[Docket No. 94-NM-28-AD]

Airworthiness Directives; Boeing Model 767 Series Airplanes Equipped With General Electric CF6-80C2 Series Engines

ACTION: Notice of proposed rulemaking (NPRM).

Electro-Mechanical Brake and CDU Cone Brake Torque Check
Figure 1

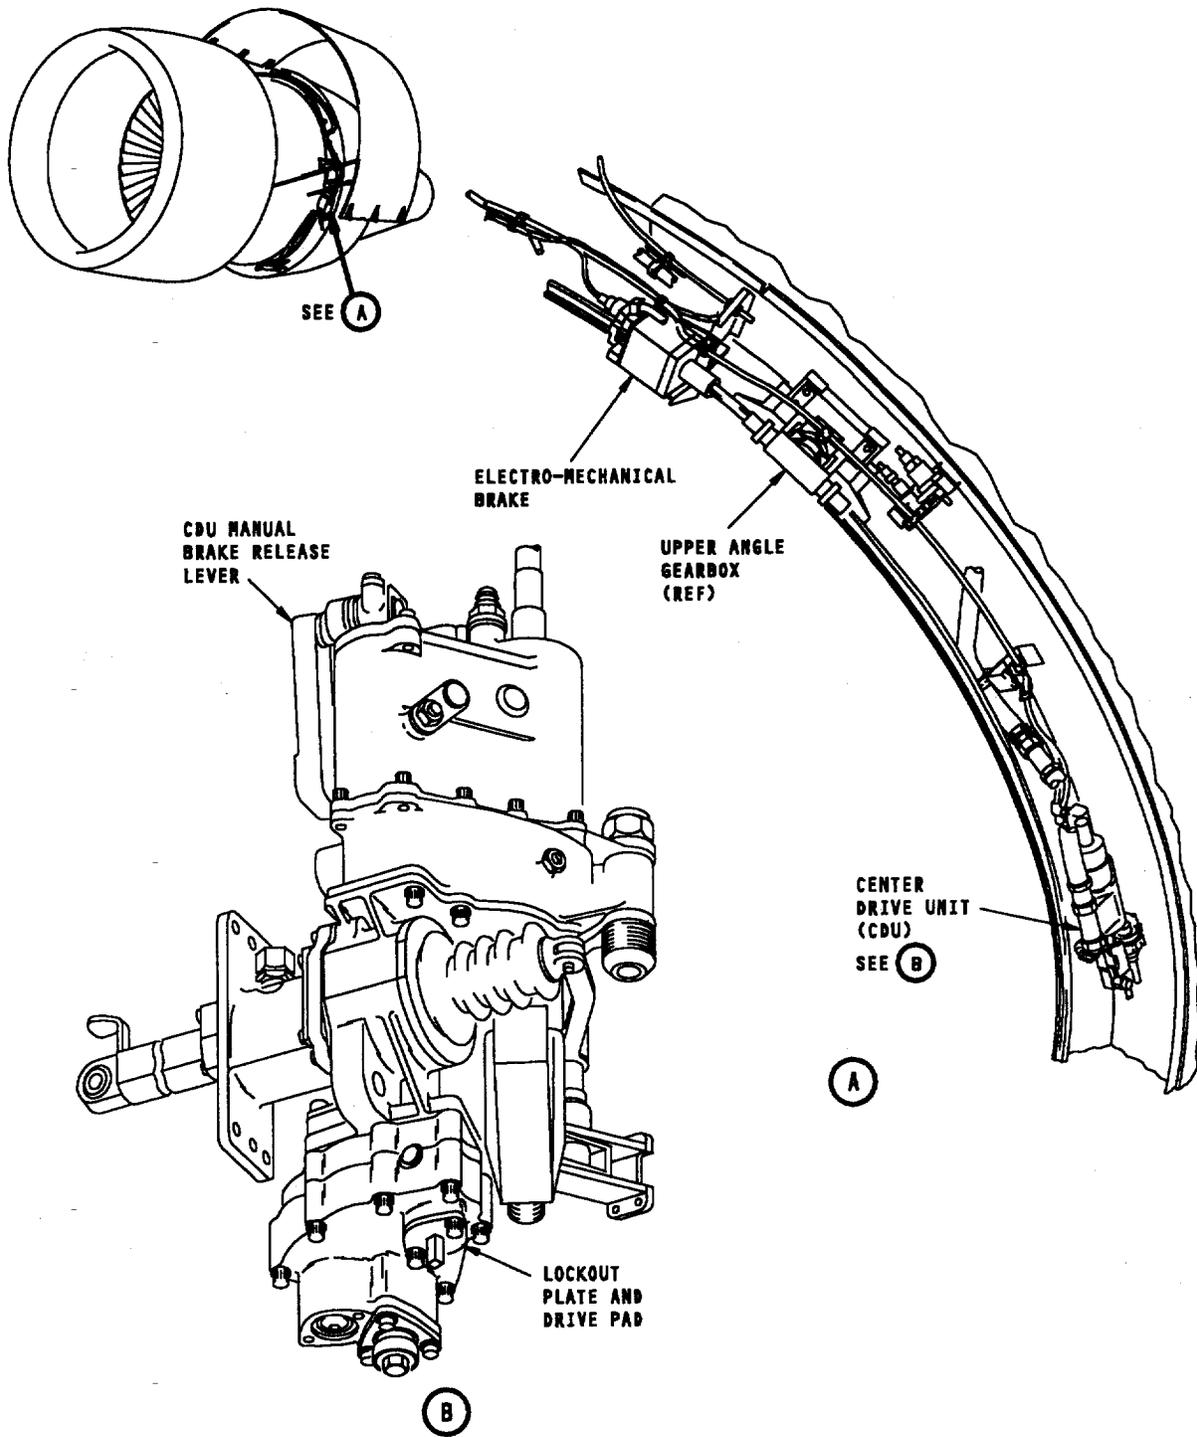
(d) Within 4,000 flight hours after accomplishing the modification required by paragraph (c) of this AD, or within 4,000 flight hours after the effective date of this AD, whichever occurs later; and thereafter at intervals not to exceed 4,000 flight hours; perform operational checks of the electro-mechanical brake and the cone brake of the center drive unit in accordance with Appendix 1 (including Figure 1) of this AD.

2. Electro-Mechanical Brake and CDU Cone Brake Torque Check (Fig. 1)

- (e) Apply 90 pound-inches of torque to the system.

(1) The electro-mechanical brake system is working correctly if the torque is reached before you turn the wrench 450 degrees (1-1/4 turns).

(2) If the flexshaft turns more than 450 degrees before you reach the specified torque, you must replace the long flexshaft between the CDU and the upper angle gearbox.

- (6) Turn the torque wrench to try to manually extend the translating cowl until you get at least 15 pound-inches.

- (a) If the torque is less than 15 pound-inches, you must replace the CDU.
